SITE PROBLEM
REPORT TRANSMITTAL

FILE: 13-14-386
CONTRACT NO: 620-00 14
SPR 386
TITLE Electronic
Relief Valve Modification
DATE: 3/27/78
STATUS CODE C

BASCO & WILCOX SPR #386

CUSTOMER Toledo Edison Company	ORIGINATOR F.R. Faist	DATE 11/2/77	DOC. NO. CONT. NO. 13 - 600-0014	SPR NO. 386
VENDOR Crosby	P.A. NO. 023 090 IS		PART NO./IATA NO. 28/041/005	GROUP NO. 1
TITLE (MAX 30 CHARACTERS) Electronic Relief Valve Modification			PROBLEM CONTACT J. E. Anderson

CROSBY WAVE & G.C.
VIREN, MA, MASS.
P.O.C (PILOT WAVE)
100-1-SN

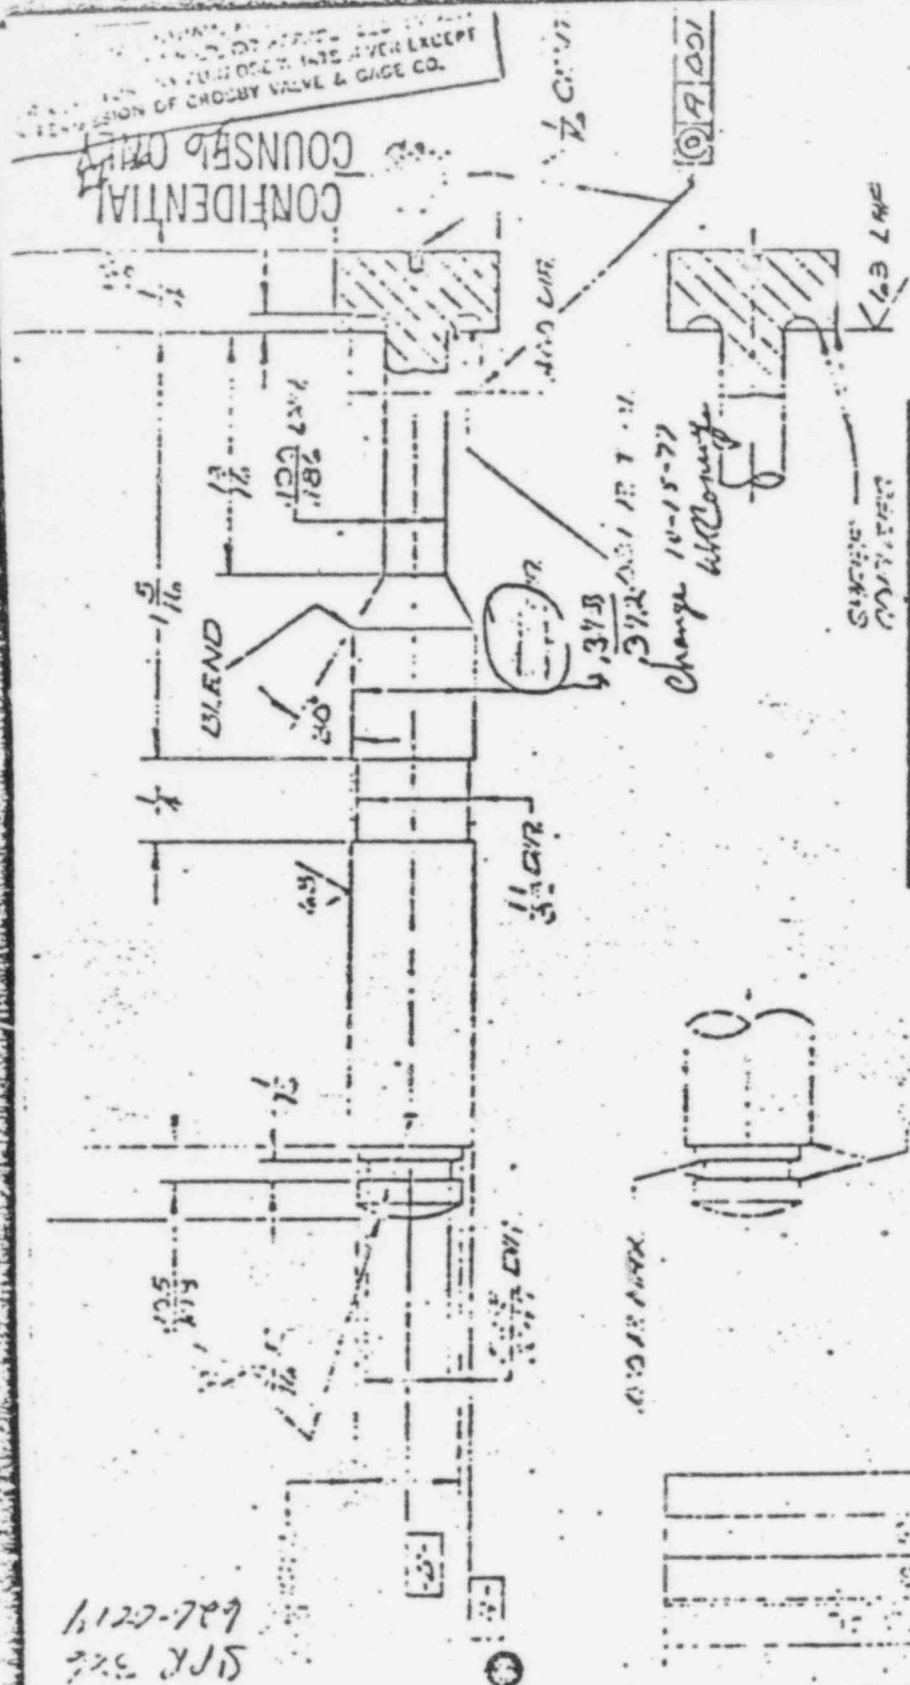
The Crosby representative furnished a detailed drawing of the pilot valve stem requiring a diameter of .374. This was changed to read .373 diameter .372.

by the Crosby rep., and the stem was modified accordingly by TECO Maintenance under the direction of the Crosby rep. This modification resulted in opening the clearance between the stem and the nozzle thus eliminating the binding. The nozzle was also reamed out with a reamer the same size, no material was removed.
